Submission Title: [802.15.3c comment resolution on #7]

Date Submitted: [March 18, 2008]

Re: [In response to IEEE P802.15-08-0020-03-003c-df0-comments]

Abstract: [This document provides revised Block-Ack frame format.]

- Revised Blk-ACK frame format
 - Unified format

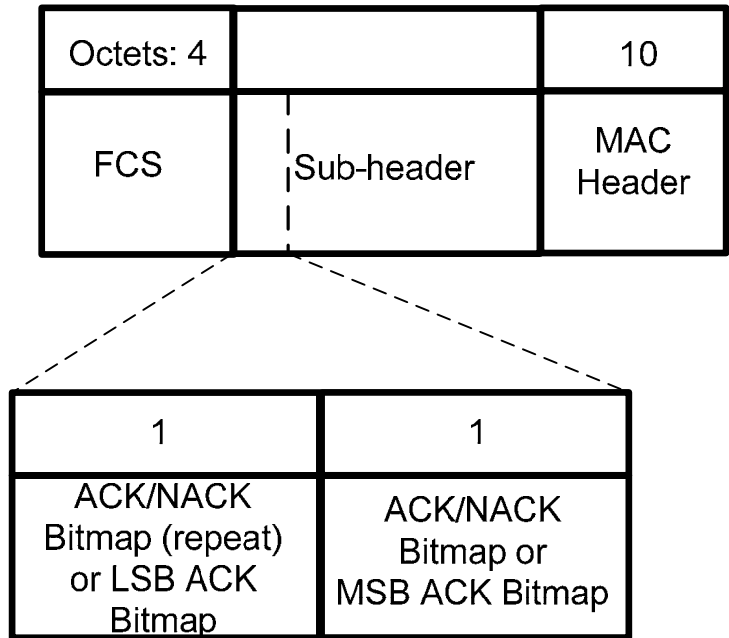
- Implicit Blk-ACK frame format
 - Payload data may or may not consist of multiple sub-frames

- Why Implicit Blk-ACK frame format is necessary for UEP video applications?
 - E.g.1, video conference applications require aggregated frames being transmitted at both ways
 - E.g.2, at downlink UEP video is streamed with aggregated frames; at uplink, some data such as control messages are transmitted with implicit Blk-ACK frames.
